SUBJECT: PLANS AND PROPOSAL ADDENDUMS
PROJECT: STP 2023 (675)MM CONTROL: 1433-02-044
COUNTY: COMAL
LETTING: 05/04/2023
REFERENCE NO: 0419

PROPOSAL ADDENDUMS

DESCRIPTION OF ABOVE CHANGES
(INCLUDING PLANS SHEET CHANGES)

MEDIAN DETAILS

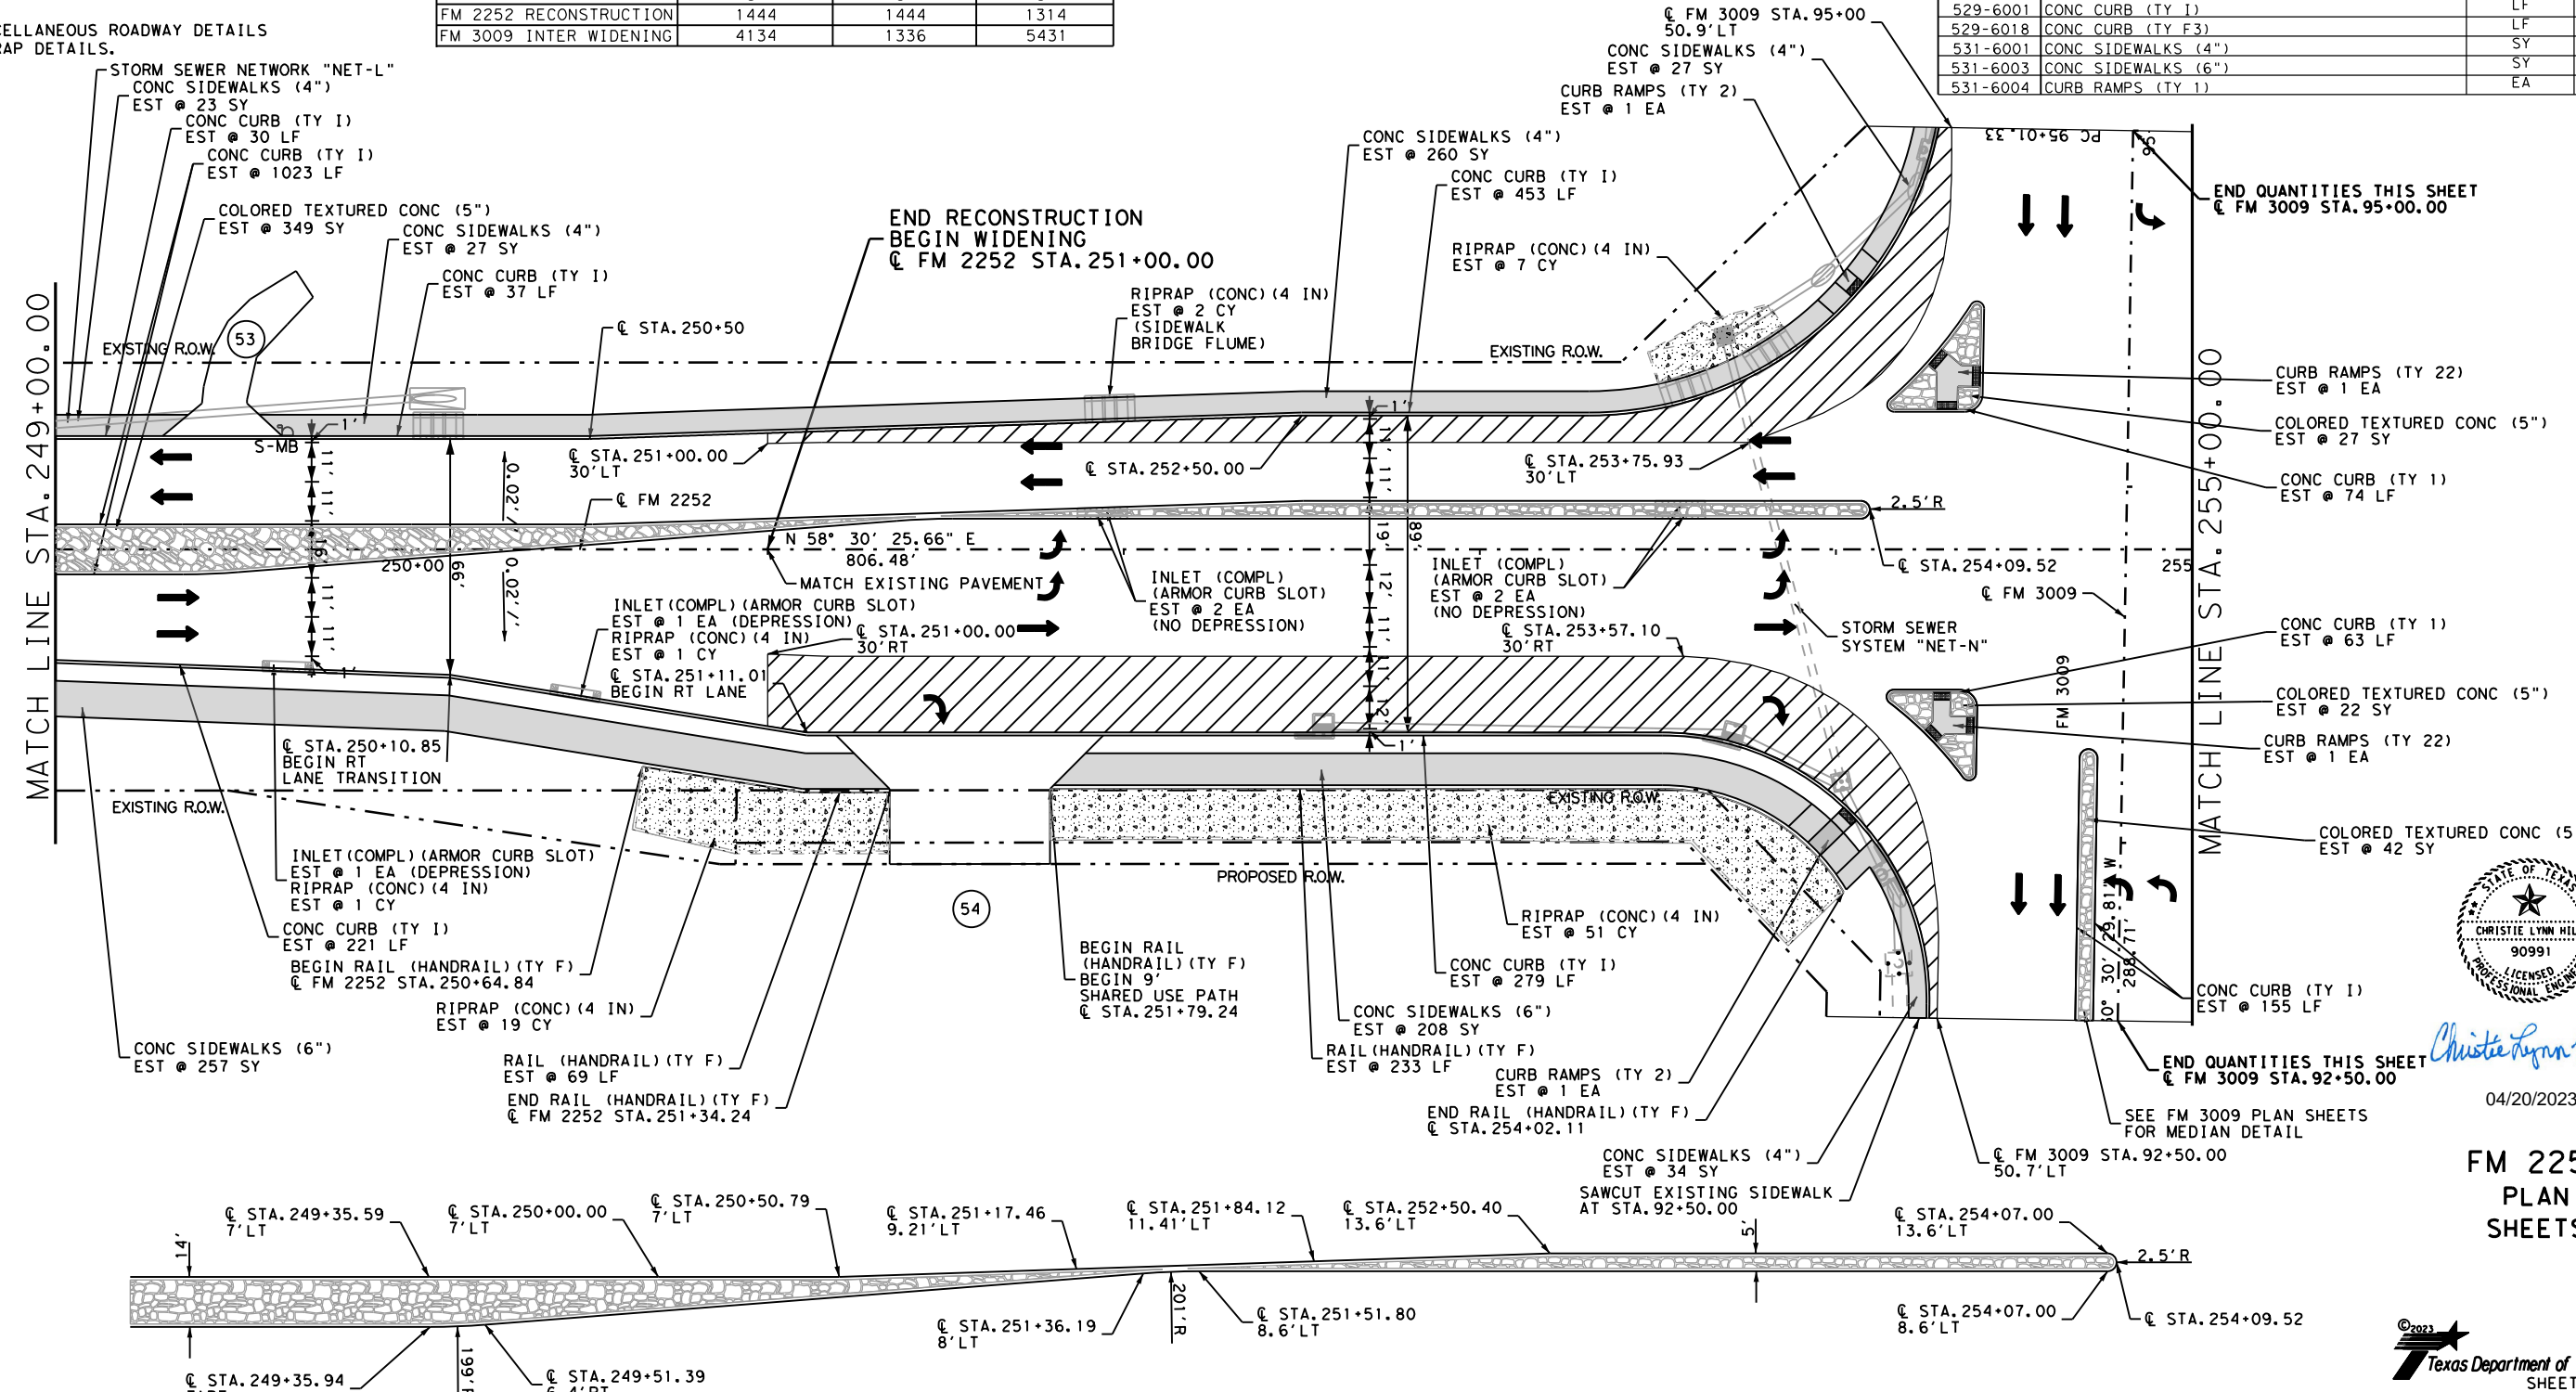
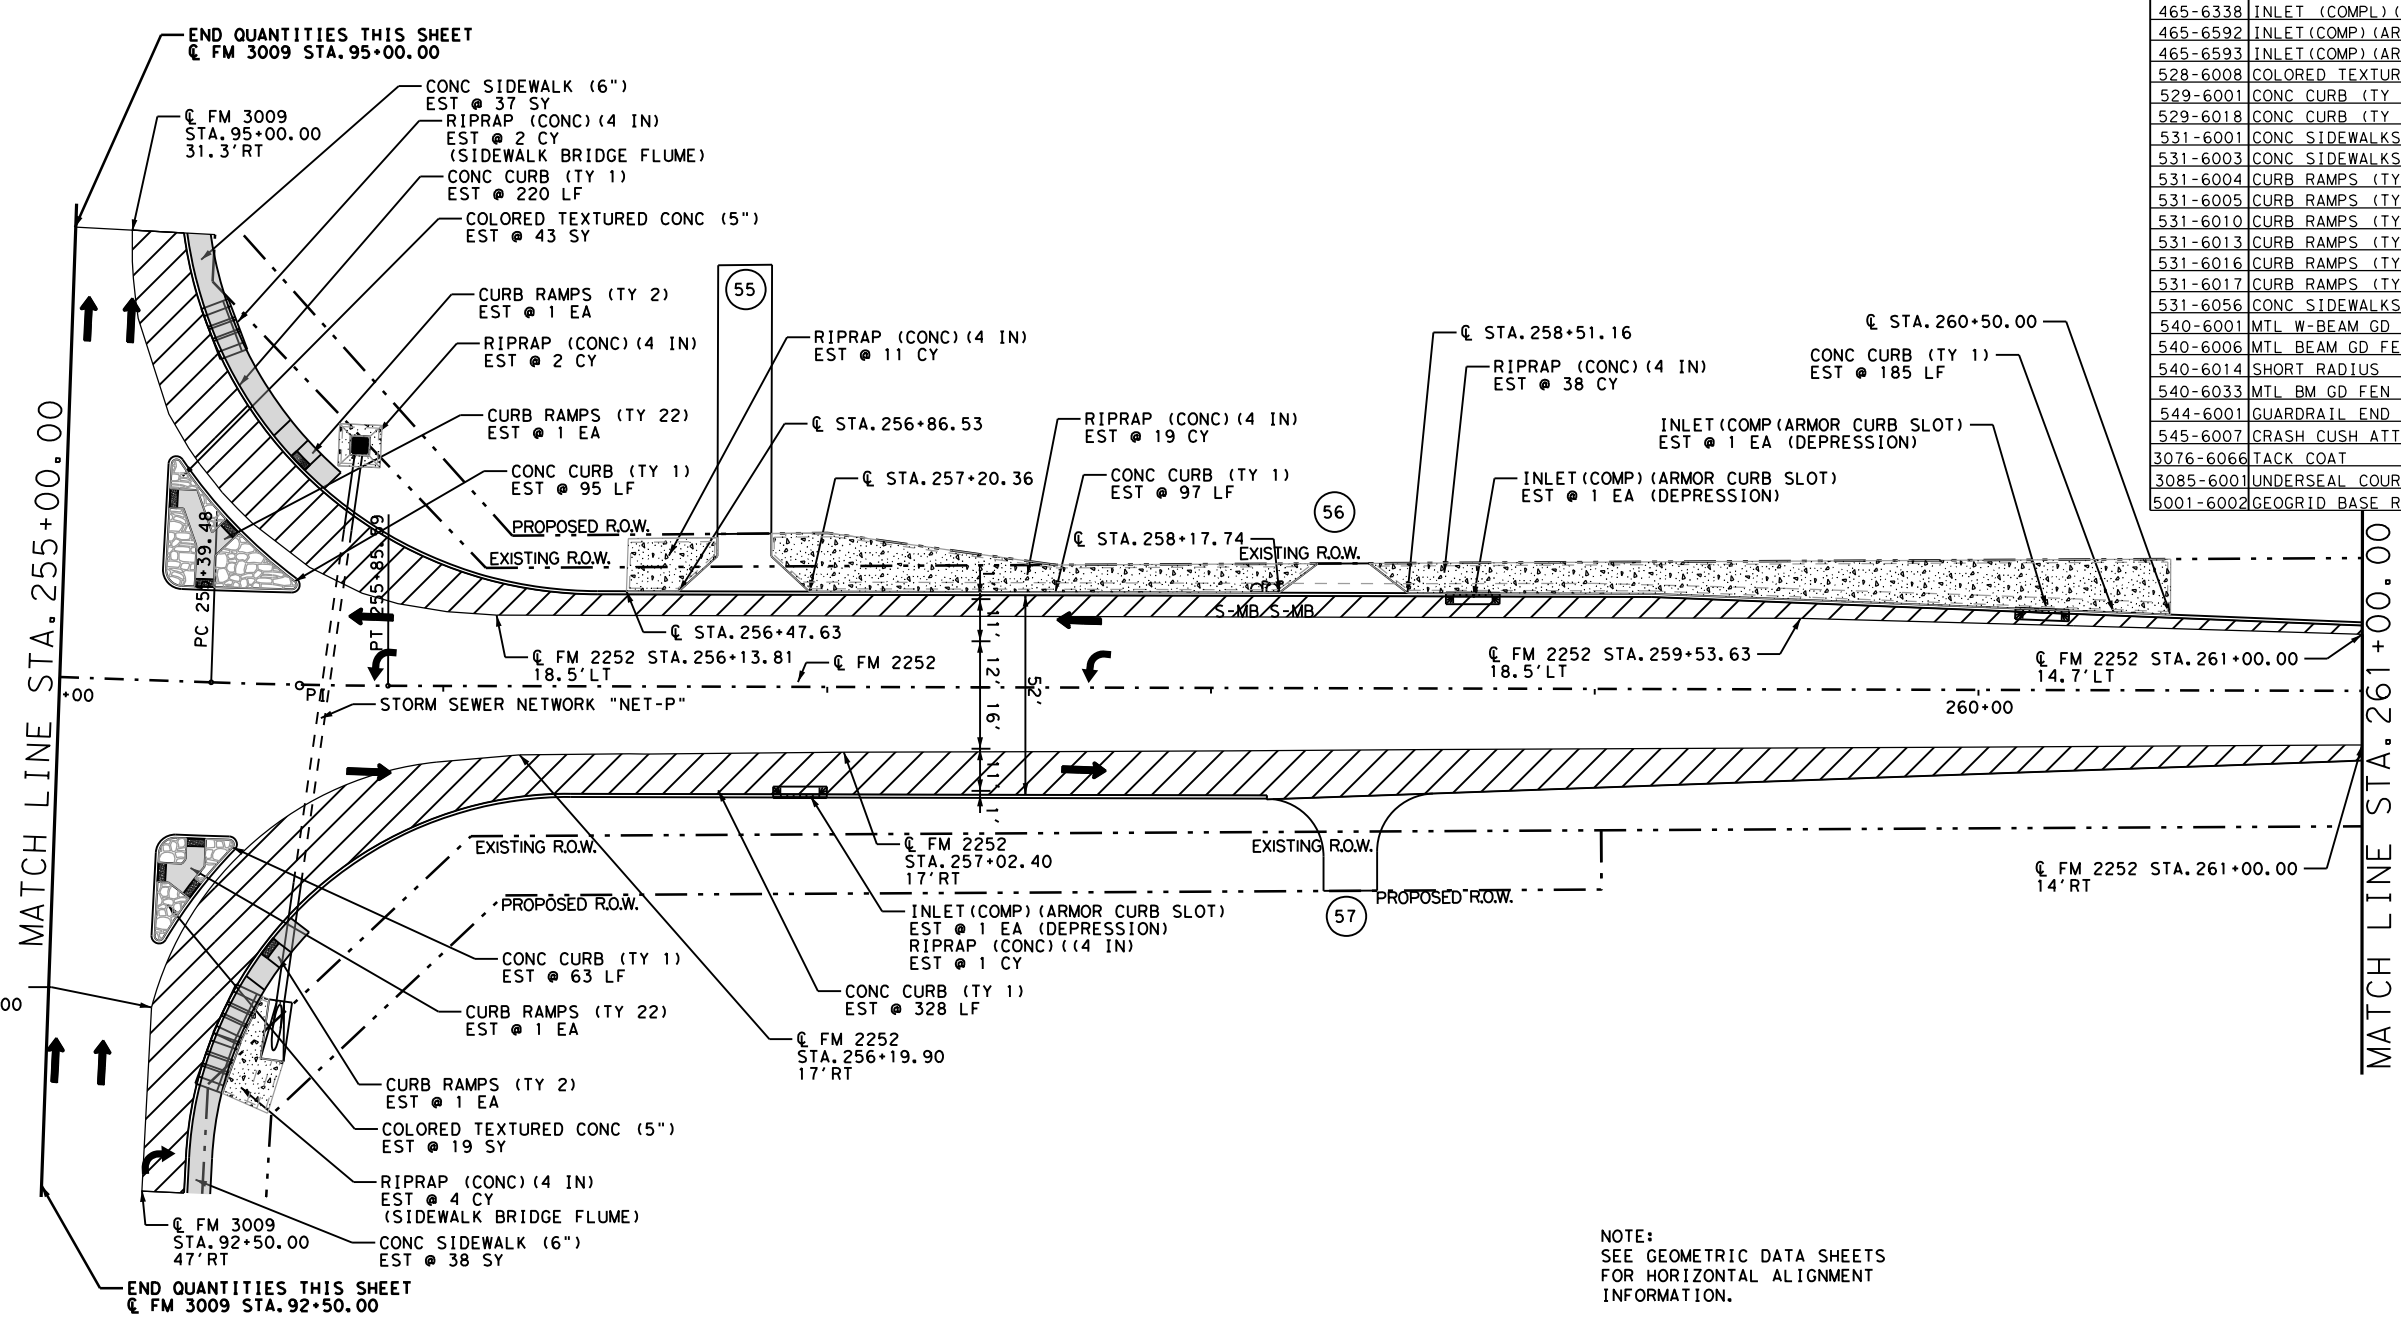
SHEETS 413-449: REPLACED ITEM NO. 545-6017 WITH ITEM NO. 545-6007
